MAINE TURNPIKE AUTHORITY

ADDENDUM NO. 2

CONTRACT 2019.02
KENNEBUNK TRAVEL PLAZAS
PARKING
EXPANSION MILE 25.5 SB AND NB
AND ROUTE 35 TRAFFIC SIGNALS

The following changes are made to the Proposal, Specifications and Plans.

STANDARD PIPE/WATER LINE TRENCH DETAIL
N.T.S.

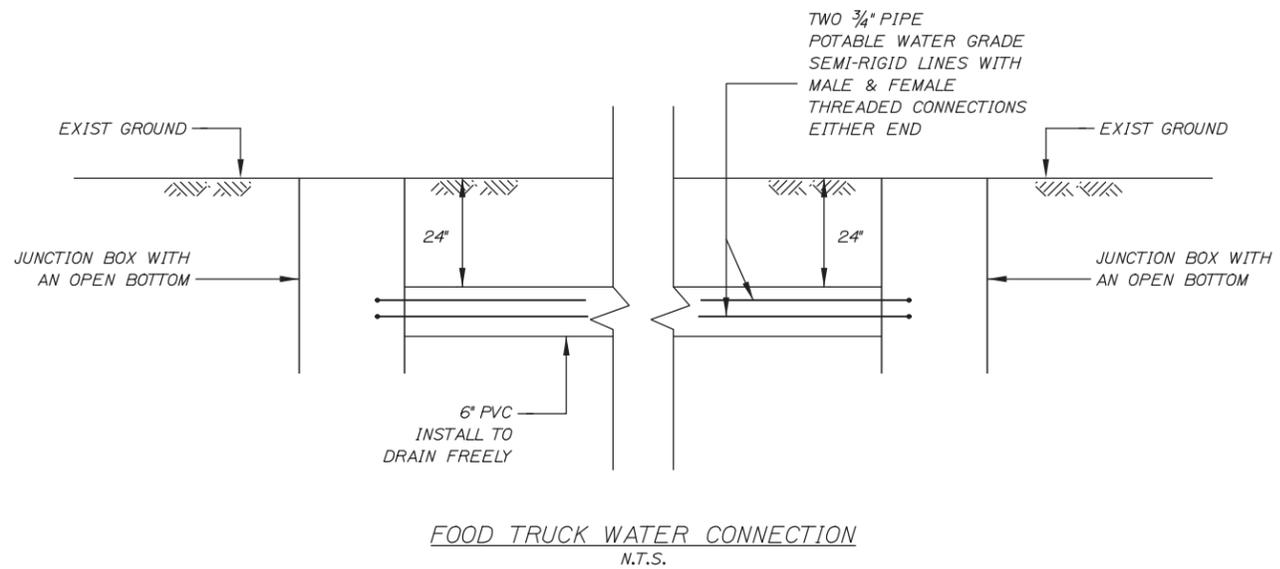
Question 10: Can the minimum width for the pipe & conduit trench details located on sheet CD-06 & LGT-02 be confirmed?

Answer: The minimum width on sheet CD-06 has been updated to be $\frac{1}{2}$ ID + 1.5 FT (min. 3 FT). This detail label has also been revised to remove the reference to conduits.

SIGNAL PLAN 1

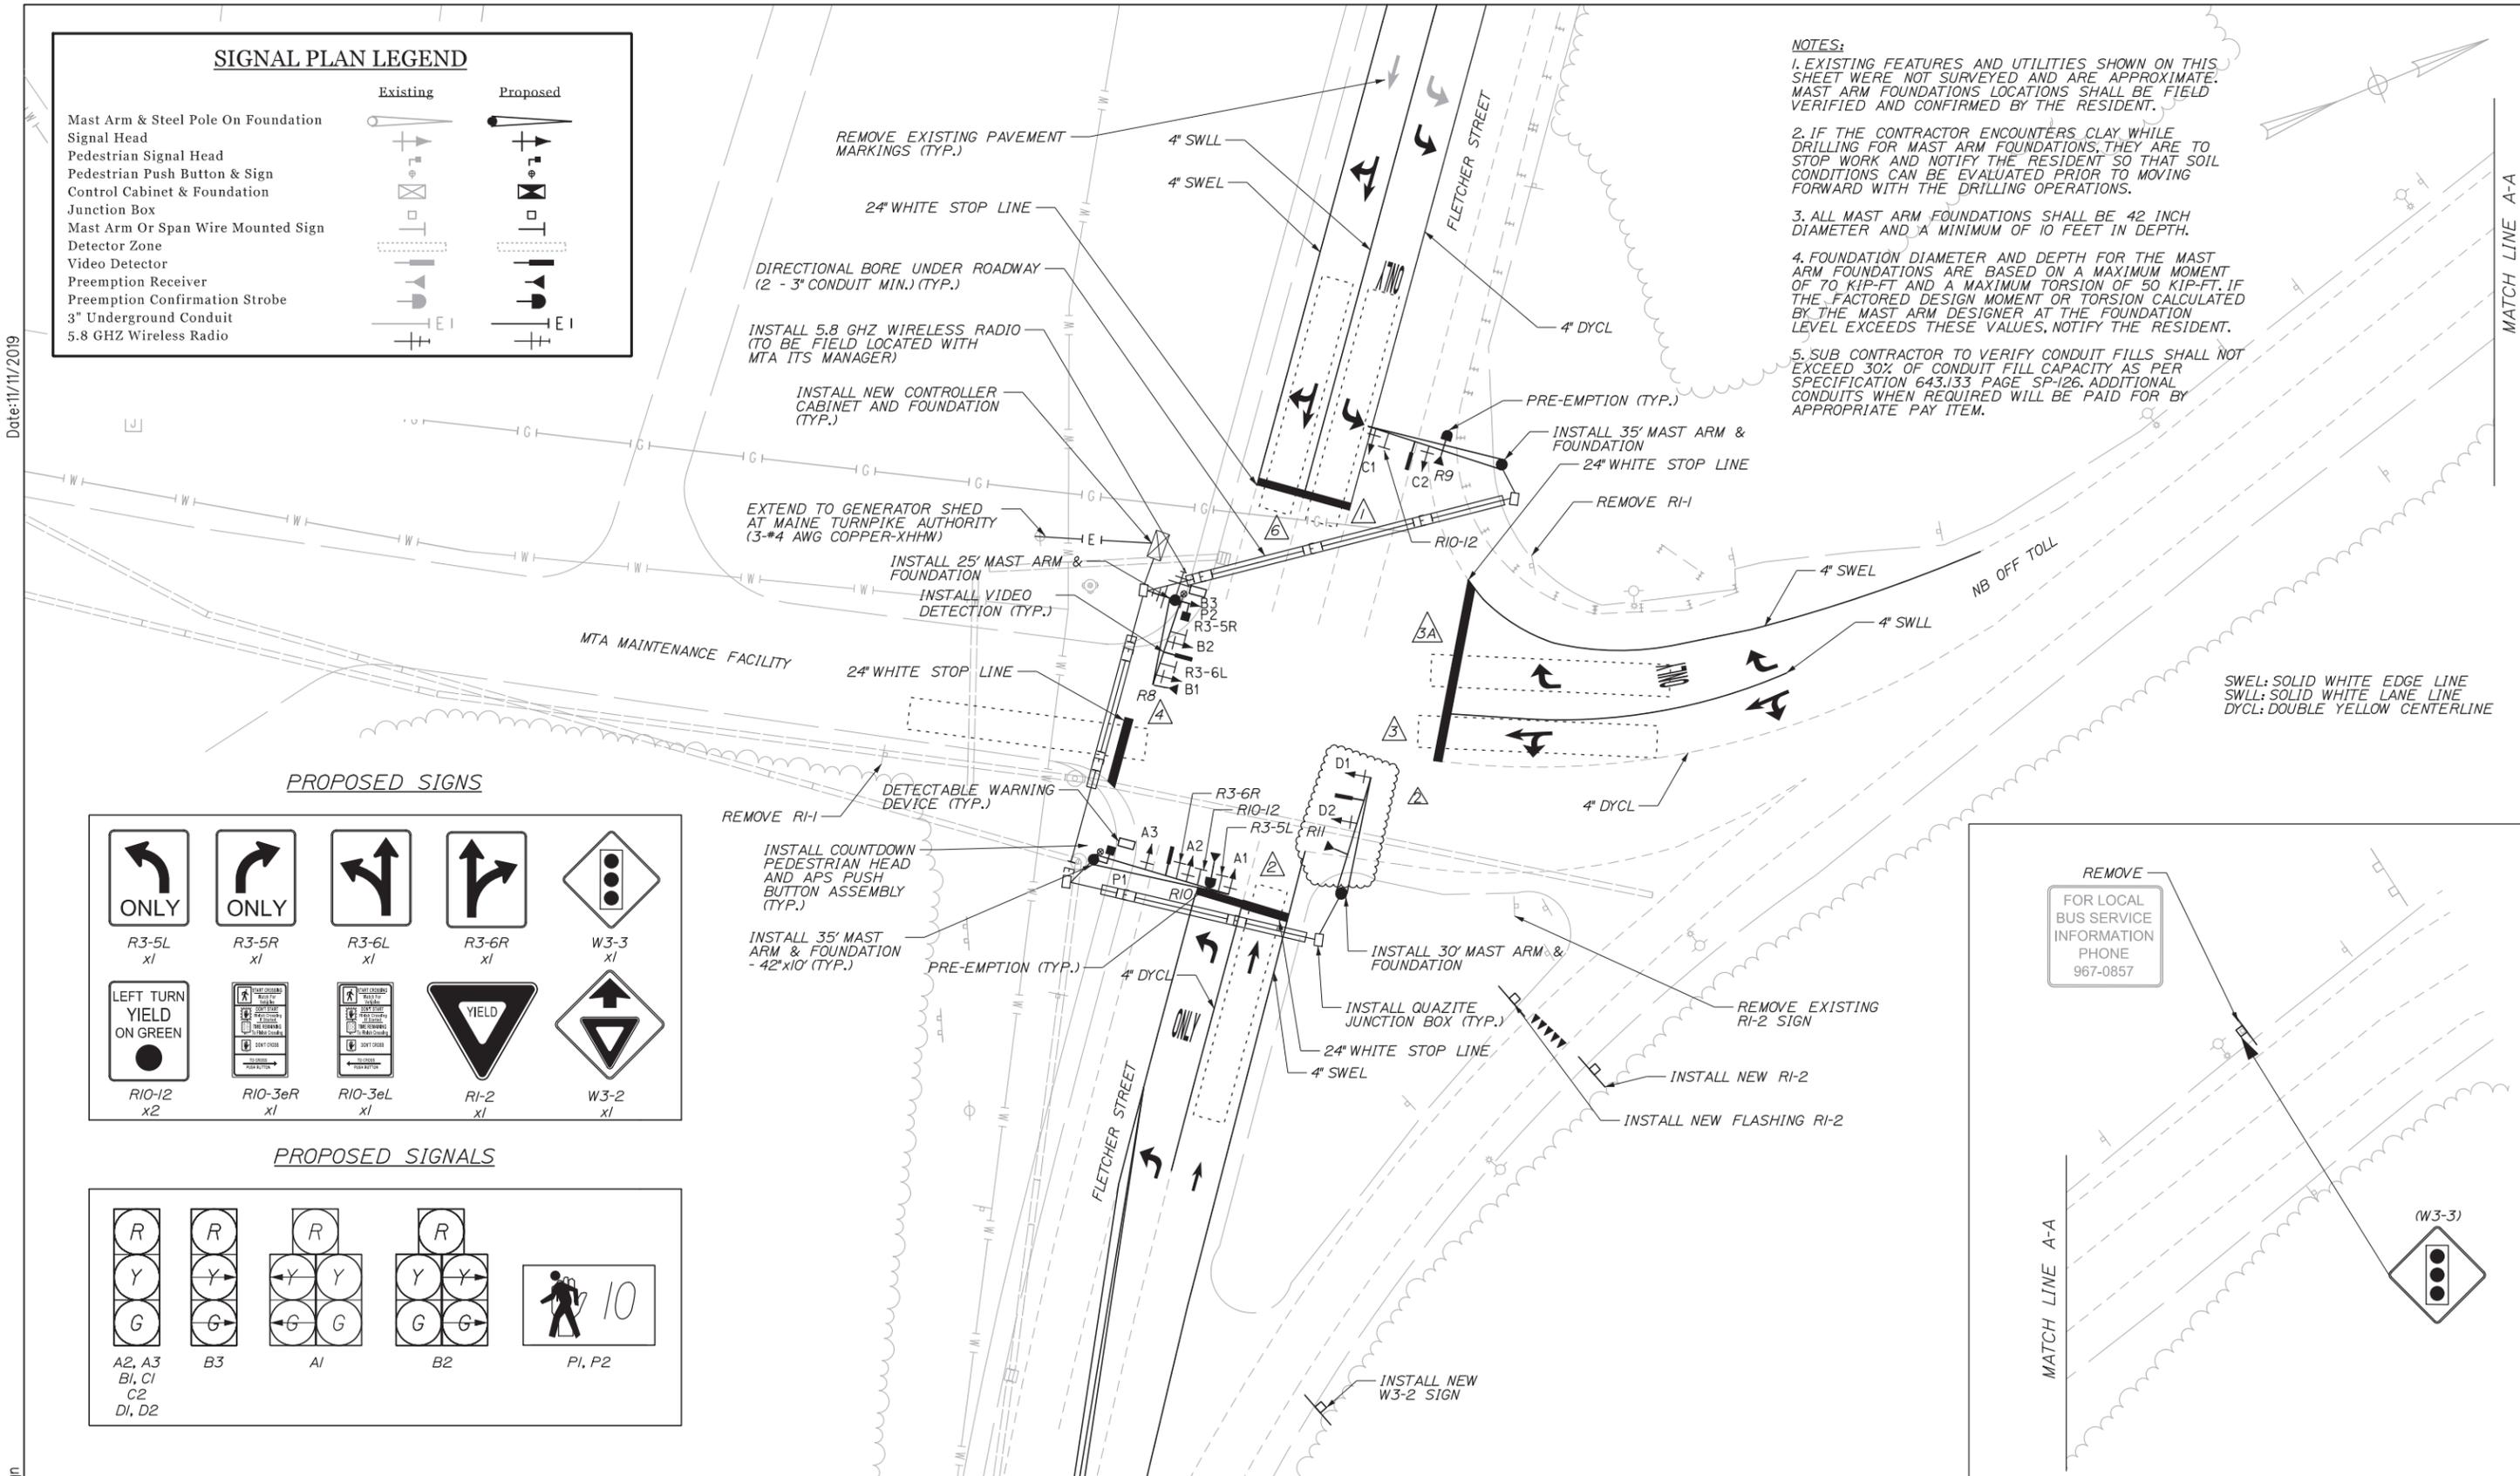
Question 7: Can you confirm that the 30' Mast Arm in the North West is 30' and not 25' as measured.

Answer: Mast arm drafting and the equipment and work items list has been updated. The mast arm was labeled correctly.

SIGNAL PLAN 2

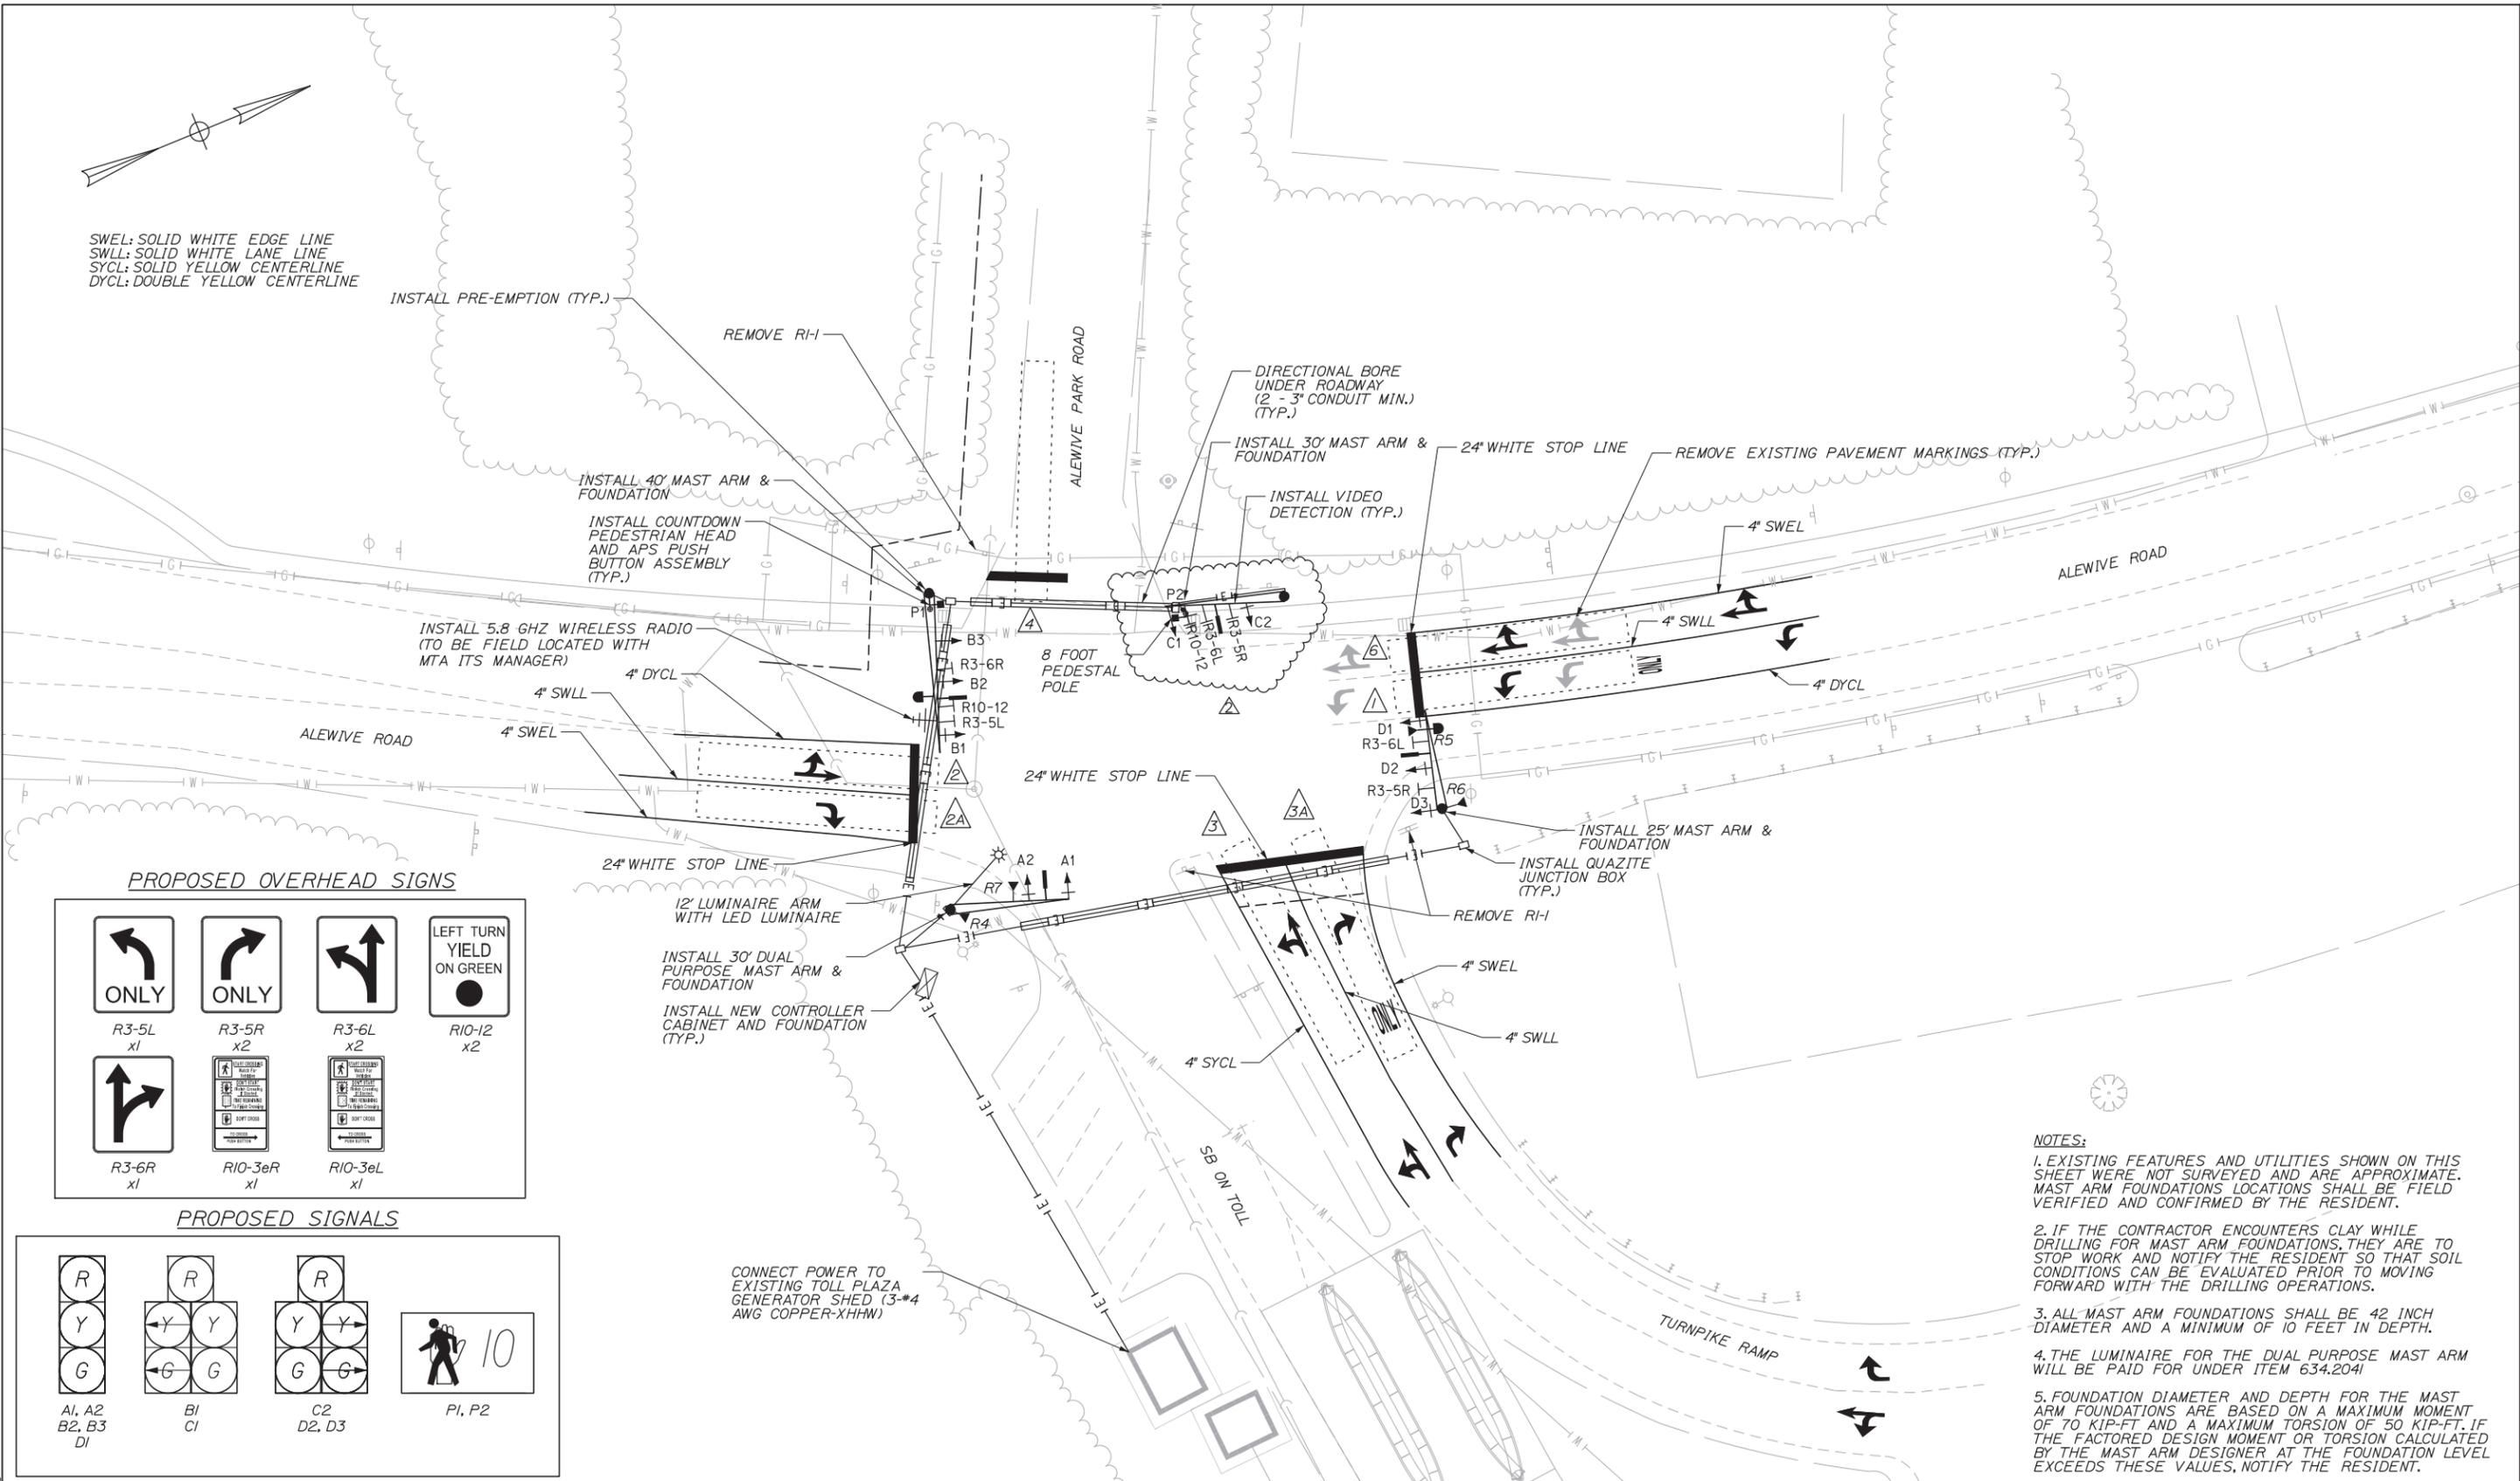
Question 6: Is the scale on Signal Plan 2 is correct at 1"=50' or should it be 1"=40'?

Answer: The scale should be 1"=40'.

SHEET NUMBER: SGNL-04
 103 OF 158

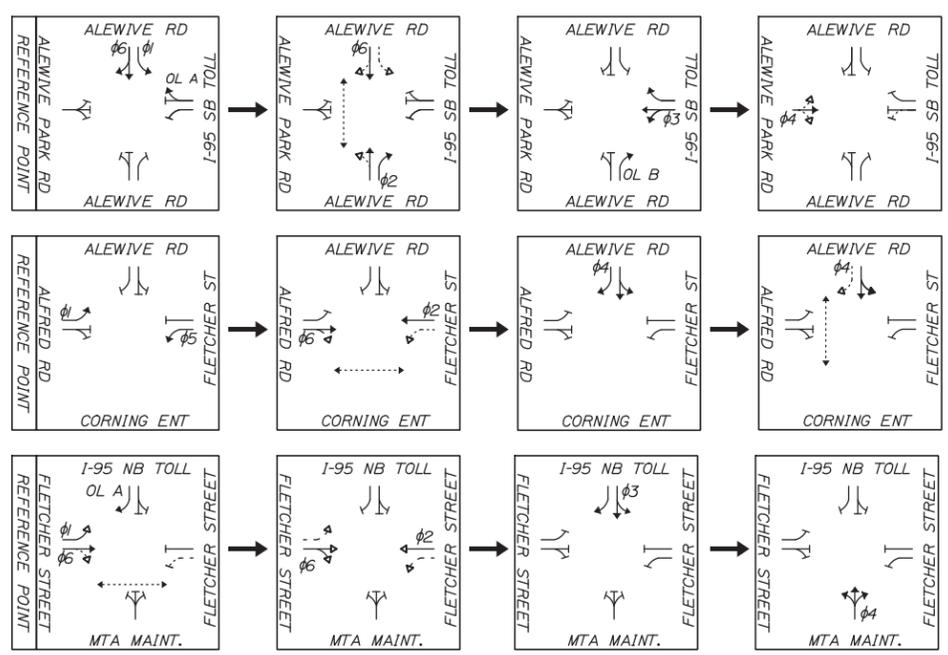
Question 8: The signal time for Alewife and Alfred road is missing the phase 4 pedestrian timing, can the MTA please provide this timing. Also, the pedestrian clearance timing for phase seem longer than need, can the MTA please confirm.

Answer: Sheet SGNL-04 has been revised.
